**Table 4. Caliper Replacement Part Numbers**

**Figure 1. Recall Caliper Kits**

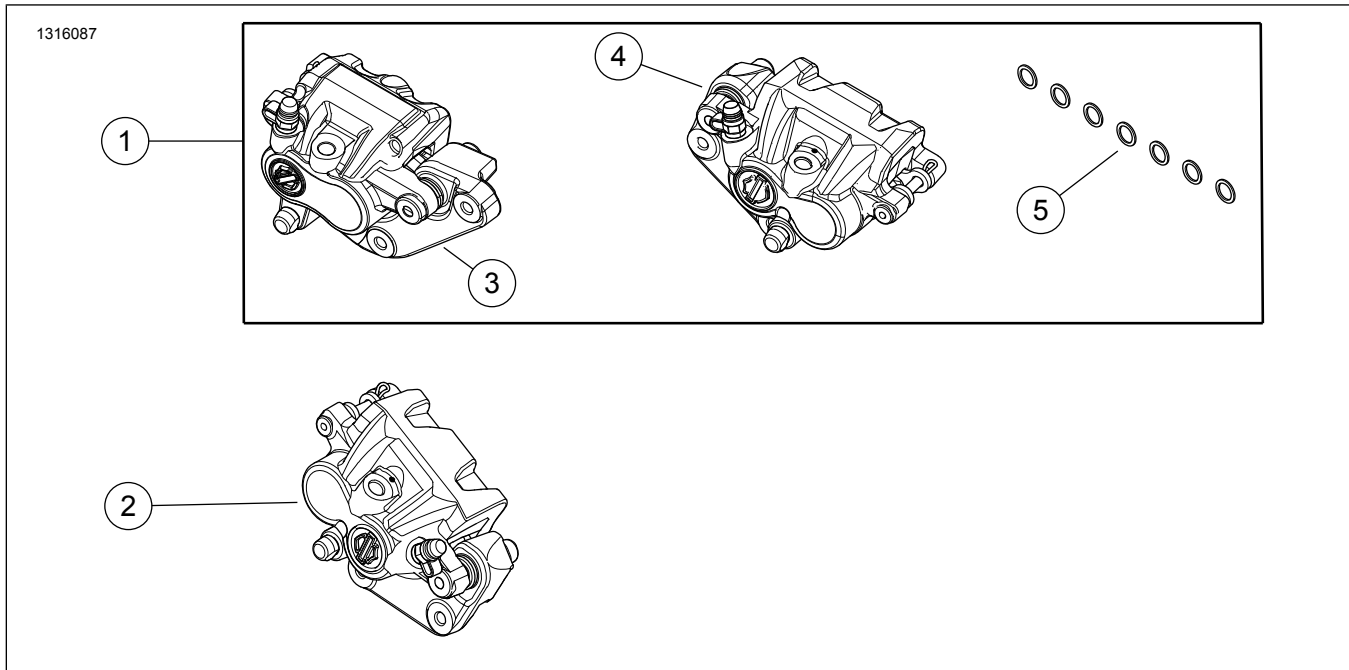
2. Replace the calipers by following the service manual for the year and model of the vehicle this bulletin is being applied to.

(1) Installing kit 91500097 uses four washers, installing kit 91500098 uses three washers. There will be three extra washers after installation of kit 91500097 only.

(2) Both kits 91500097 & 91500098 must be installed on 750A models.

Models	Item	Kit	Kit Items	Qty	Description	Part No.
500, 750, 750A	1	91500097	3	1	Left front caliper	41300158A
			4	1	Rear caliper	41300159A
			5	7	Banjo washers <sup>(1)</sup>	12300033
750A <sup>(2)</sup>	2	91500098	2	1	Right front caliper	41300190A
